**STAFF ANALYSIS**

The staff recommends that the Toledo City Plan Commission recommend approval of SUP24-00093, a Special Use Permit for used car dealership at 130 New Towne Square Drive, to the Toledo City Council, for the following three (3) reasons:

SPECIAL USE PERMIT  
TOLEDO CITY PLAN COMMISSION  
REF: SUP24-00093  
DATE: November 7, 2024  
TIME: 2:00 P.M.

# SITE PLAN

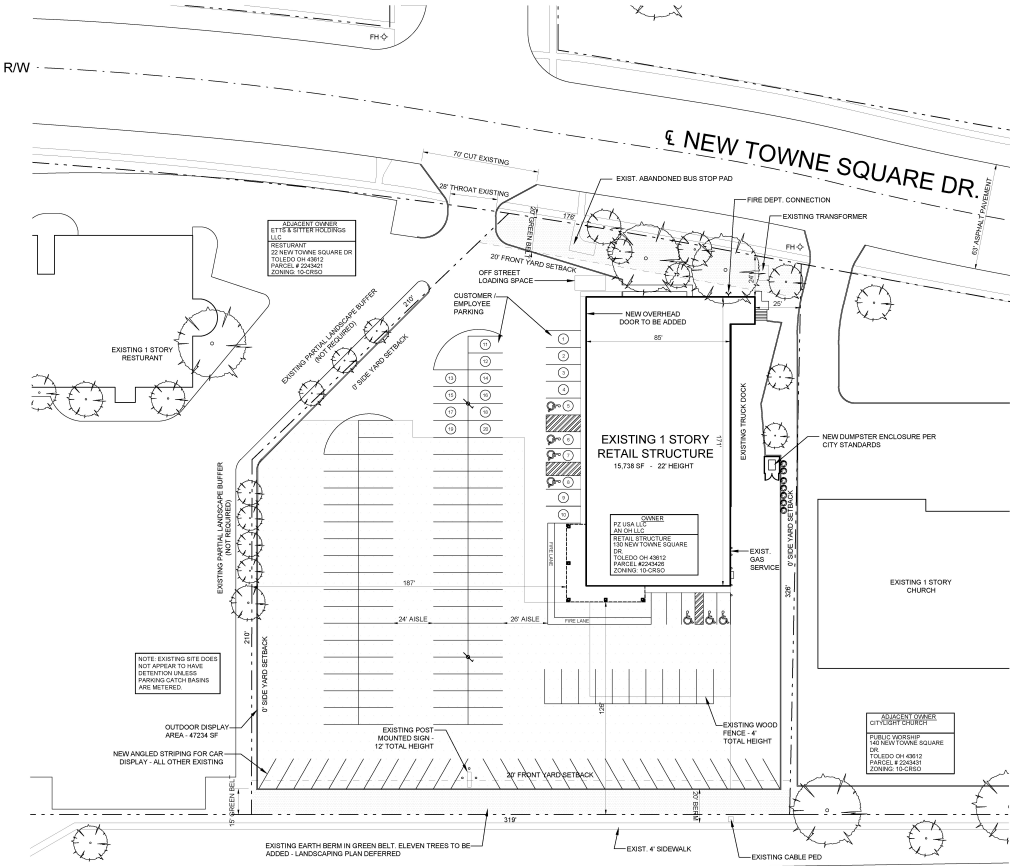
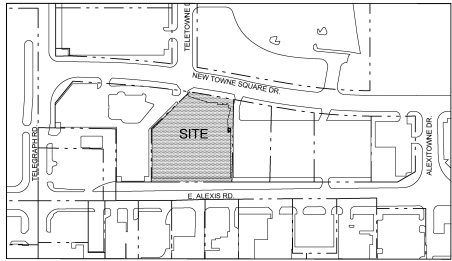
A four-foot (4') wood fence currently exists on the site south of the existing structure intersecting currently-delineated parking spaces. The site plan shows these spaces will be converted into outdoor display spaces. A revised site plan shall be submitted showing either the fence removed or the display spaces within the fence removed and listed as a condition of approval.

been shown; however, they are not clearly delineated from the outdoor display area spots. Per TMC§1104.0300, the required customer parking may not be used for used vehicle inventory. As a condition of approval, a revised site plan shall be submitted showing clear delineation between outdoor display area parking spots and customer/employee parking spots.

TMC§1107.1700 requires a portion of the total number of off-street parking spaces in each off-street parking area be specifically designated, located, and reserved for use by persons with physical disabilities. The submitted site plan shows four (4) of these accessible spaces for customer/employee parking and three (3) spaces within the outdoor display area. Since parking spaces within the outdoor display area are intended for the display of for-sale vehicles, not for customer/employee parking, there should be no need for accessible spaces within this area. A revised site plan shall be submitted showing no accessible parking spaces within the outdoor display area and listed as a condition of approval. With twenty (20) customer/employee parking spaces, one (1) van-accessible parking space is required per TMC§1107.1701. Should the number of proposed customer/employee parking spaces increase to twenty-six (26) or more based upon the previous delineation requirement, the number of required accessible parking spaces will also need to increase.

TMC§1107.1900 *Design Standards* applies to both customer/employee parking areas and outdoor display areas. Not all drive aisle and parking spot dimensions are shown; however, those that are shown reveal that the existing parking lot is not compliant with TMC§1107.1911 *Dimensions*. As a condition of approval, a revised site plan shall be submitted to both the Plan Director and the Division of Traffic Management showing all drive aisle and parking spot dimensions compliant with TMC§1107.1911.

24. Used vehicle inventory shall only be displayed, parked or located within the outdoor display area defined on the site plan.
25. The existing four foot (4') wooden fence between the structure and Alexis Road shall either be removed or have all parking/display spaces removed from within its enclosure. **This shall be depicted on a revised site plan submitted to the Plan Director.**

26. Off-street parking spaces for customers/employees shall be clearly delineated from spots within the outdoor display area. **Not acceptable as depicted. A revised site plan shall be submitted to the Plan Director depicting a clear delineation between outdoor display area parking spots and customer/employee parking spots.**

29. Accessible spaces may not be included within the outdoor display area. **Not acceptable as depicted. A revised site plan shall be submitted to the Plan Director depicting no accessible parking spaces within the outdoor display area.**

31. All drive aisle and parking spot dimensions shall be shown to be compliant with TMC§1107.1900 *Design Standards*. **Not acceptable as depicted. A revised site plan shall be submitted to the Plan Director and Division of Traffic Management showing compliance with all design standards.**

# LANDSCAPE PLAN

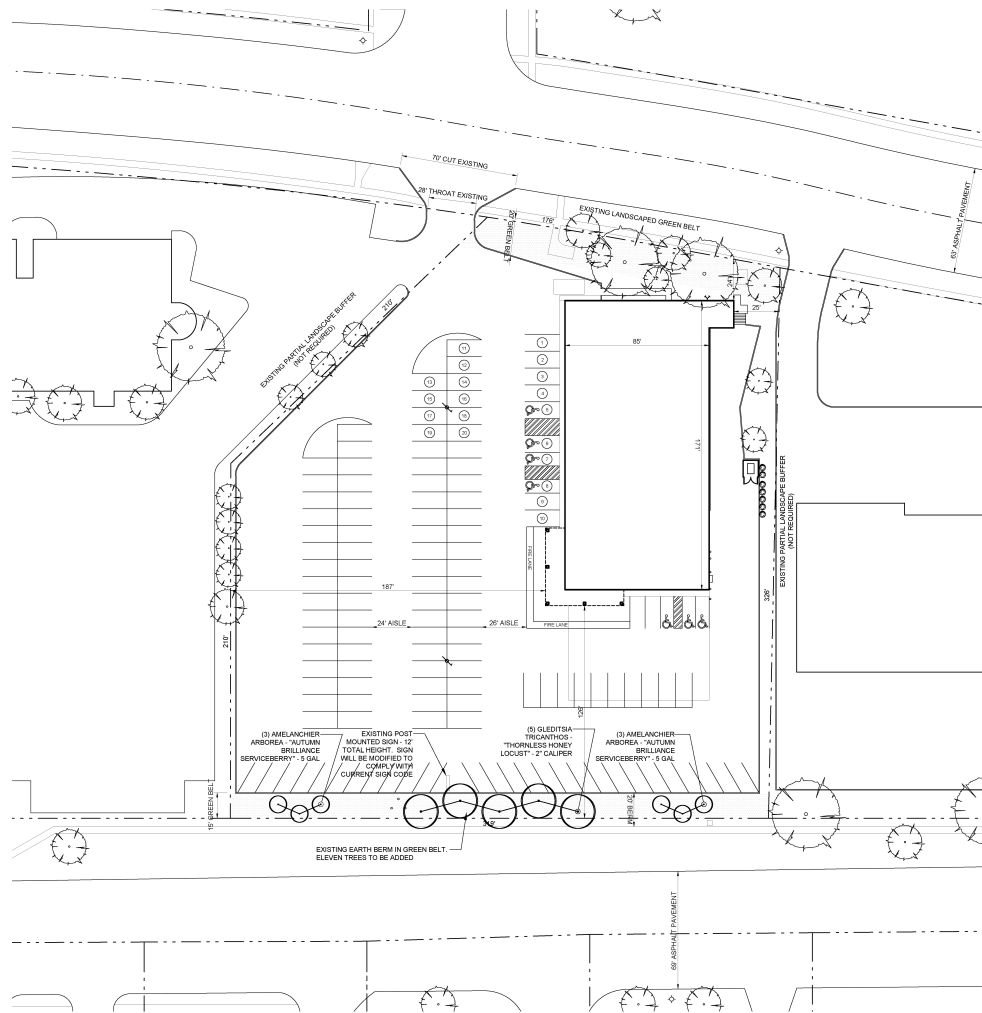
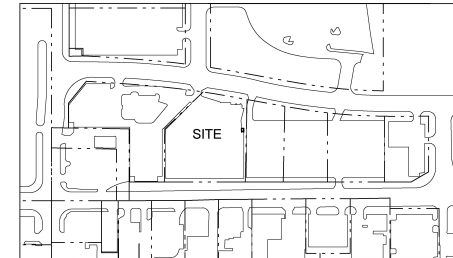
approved by the Plan Director. An acceptable earth berm exists along Alexis Road; however, no such berm exists along New Towne Square Drive. A revised landscape plan shall be submitted depicting a solid evergreen hedge within the frontage greenbelt along New Towne Square Road in front of the parking lot and listed as a condition of approval.

Perimeter parking lot landscaping must be installed along any parking lot area adjacent to a street, place, or driveway, or which is visible from an immediately adjacent property. A minimum of one (1) canopy tree must be provided for each thirty linear feet (30'). A perimeter landscape strip currently exists along the western property line containing eight (8) existing trees. While these trees appear to be on the adjacent property, their existence meets the intent of this provision. Fourteen (14) trees are required along the western property line. The existing trees can be credited for multiple trees per TMC§1108.0407 *Tree Preservation and Credit for Existing Landscape Materials*. In order to count for tree credits, trees must have their species and caliper verified and depicted on a revised landscaping plan. Staff anticipates the existing trees will receive enough credit to meet the minimum fourteen (14) trees required.

Perimeter parking lot landscaping is also required along the eastern property line. There are two (2) existing trees between the parking lot and the property line. No other trees are proposed or shown on the submitted landscaping plan; however, eleven (11) trees are required on this area. While the existing trees may be credited as multiple trees, staff does not anticipate this requirement will be met. As a condition of approval, a revised landscaping plan must be submitted depicting additional trees to meet the eleven (11) trees required. In order to count for tree credits, existing trees must have their species and caliper verified and depicted on a revised landscaping plan.

Perimeter parking lot landscaping must also contain continuous shrubs with a minimum height of eighteen inches (18") when installed so as to achieve full screening at maturity. The submitted landscaping plan shows screening shrubs only along a small portion of the eastern property line. A revised landscaping plan must be submitted showing continuous shrub plantings along both the eastern and western property lines. If the applicant cannot receive permission to plant continuous shrubs within the existing landscape strip on the adjacent property to the west, the landscaping area may need to be expanded onto the subject property.

- b. A fifteen-foot (15') buffer of landscaped frontage greenbelt is required along New Towne Square Drive. At least one tree must be provided for every 30 feet of lot frontage. The frontage greenbelt shall also include a solid evergreen hedge to screen parking in the front of the property and prevent headlights from being seen from the right-of-way. **Not acceptable as depicted. A revised landscaping plan shall be submitted to the Plan Director depicting a solid evergreen hedge within the frontage greenbelt along New Towne Square Road where the parking lot is visible.**

- c. Perimeter parking lot landscaping is required along the western property line. A minimum of one (1) canopy tree must be provided for each thirty linear feet (30'). **Not acceptable as depicted. Fourteen (14) trees required. Existing trees on the abutting property may be credited for multiple trees per TMC§1108.0407. In order to count for tree credits, trees must have their species and caliper verified and depicted on a revised landscaping plan.**

- d. Perimeter parking lot landscaping is required along the eastern property line. A minimum of one (1) canopy tree must be provided for each thirty linear feet (30'). **Not acceptable as depicted. Eleven (11) trees are required. Existing trees on the abutting property may be credited for multiple trees per TMC§1108.0407. In order to count for tree credits, trees must have their species and caliper verified and depicted on a revised landscaping plan.**

- e. Perimeter parking lot landscaping along the eastern and western property lines must contain continuous shrub plantings with a minimum height of eighteen inches (18") when installed so as to achieve full screening at maturity. **A revised landscaping plan shall be submitted to the Plan Director depicting continuous shrub plantings along both the eastern and western property lines. Western property line shrub plantings may be depicted on the adjacent property if permission is given by the adjacent property owner.**
